I am writing to you to object to the proposed development of SSD-55844212 Triniti Lighthouse Build-to-Rent in North Ryde. I am a homeowner residing within Building B of the adjacent Ryde Gardens complex in an east-facing apartment on a lower level. I strongly oppose the proposed development for the following reasons:

Figure 4: Midwinter sunrise 7:06am

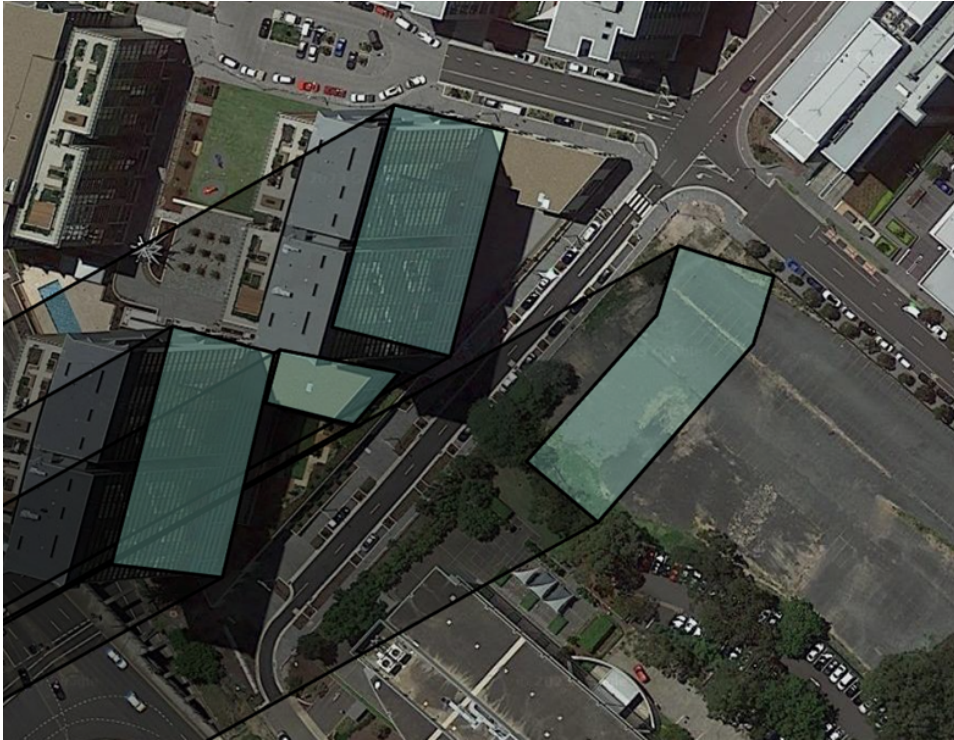
Under current conditions, many east-facing apartments in Ryde Gardens Building B receive little to zero direct sunlight at midwinter, particularly those on the lower levels. Figures 2 and 3 illustrate the shadows cast by the Ryde Gardens buildings at sunrise to 10:15am. The proposed Trinita Building A would magnify the lack of sunlight by also diminishing the amount of indirect sunlight received.

Figure 10: Equinox 7:45am

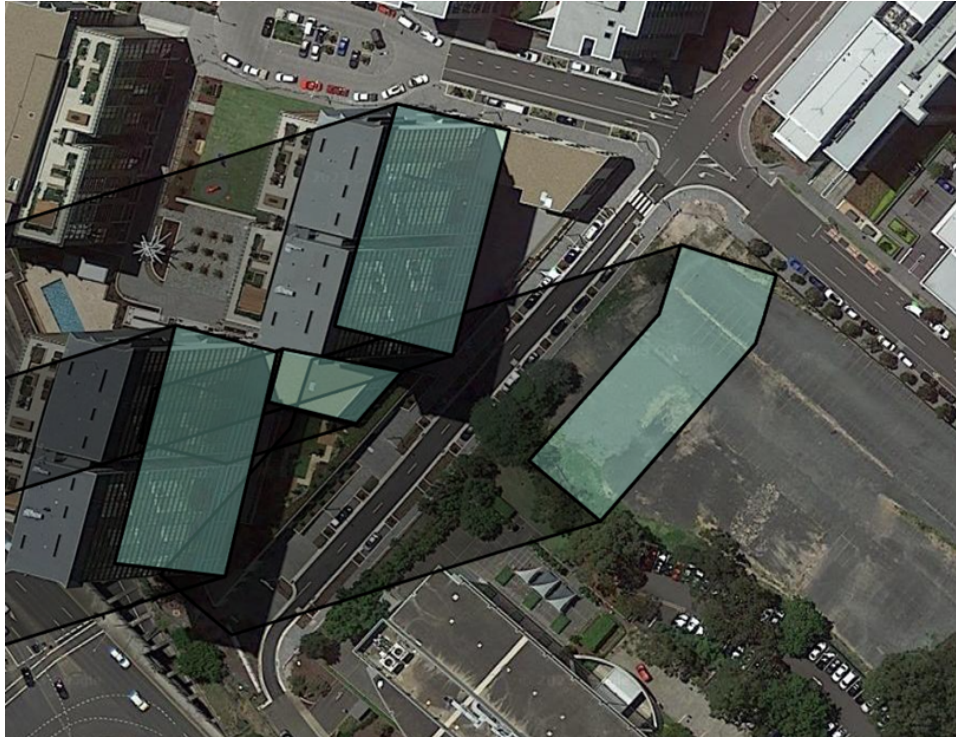
At equinox, lower levels of Building B currently receive approximately 3 hours of direct sunlight from sunrise at 5:47 am to 9:00 am. The proposed Trinita Building A at 65M would result in a decreased level of sunlight for Ryde Gardens Building B, reducing by 81% of current conditions at 35 minutes of direct sunlight from 8:25 am to 9:00 am.

Figure 19: Midsummer 8:30am

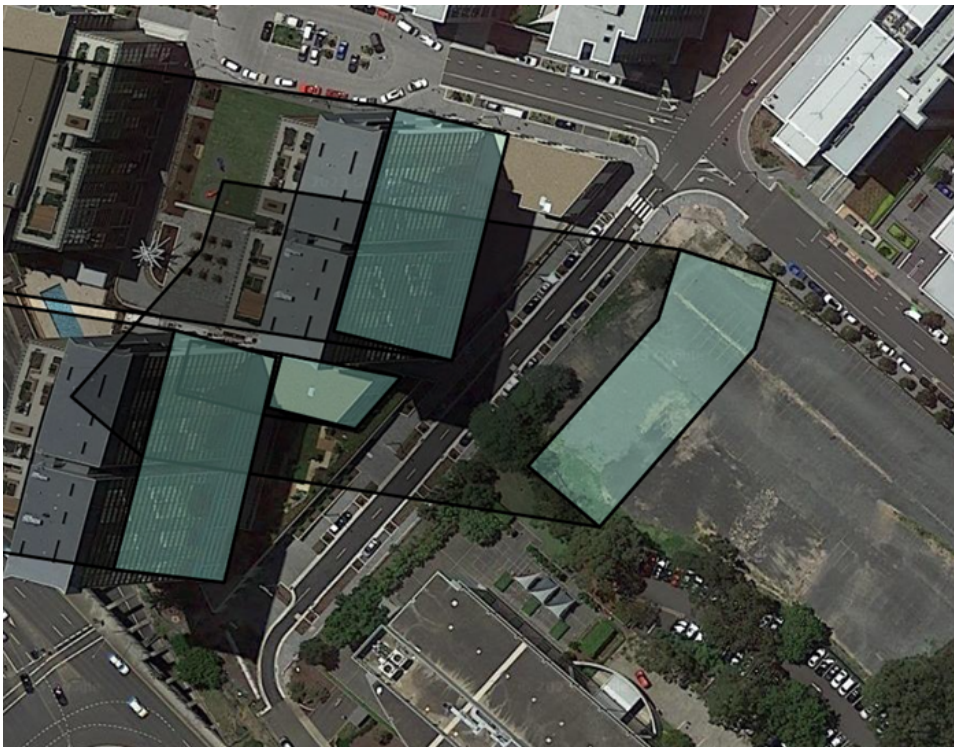
At midsummer, lower levels of Building B currently receive approximately 6 hours 45 minutes of direct sunlight from sunrise at 5:43am to 12:30pm. The proposed Trinita Building A at 65M would result in a decreased level of sunlight for Ryde Gardens Building B, reducing by 15% of current conditions at 5 hours 45 minutes of direct sunlight from sunrise at 5:43am to 12:30pm but blocked from 8:30am to 9:30 am.
